## Nikola Jr Transmitter and Receiver Bottom Panels with proposed FCC and S/N indention locations.

(Rip has all the specs needed to complete by 12/12/08)

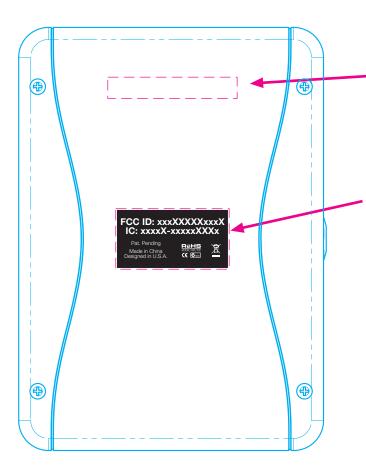
Font size for FCC spec to = 7 points

Outer diamter of sticker = 29mm W x 15mm H.

Indention area in bottom panels need an inner diameter of 30mm x 16mm (minimum) (shown in red dashed outline)

Indention needed just above the curvature of the bottom portion of rear panel for the S/N sticker.

To be the same dimensions as used on GVO's bottom panel indention. (i don't have those dimensions. The outline shown here is for reference only...)

Indention needed for the S/N sticker here. (Again Outline for reference only as I don't have the SN sticker's dimensions but it should be centered in this area.)

We have more room on the bottom panel of the Receiver but require the same minimum indention diameter as shown above for the FCC Sticker.
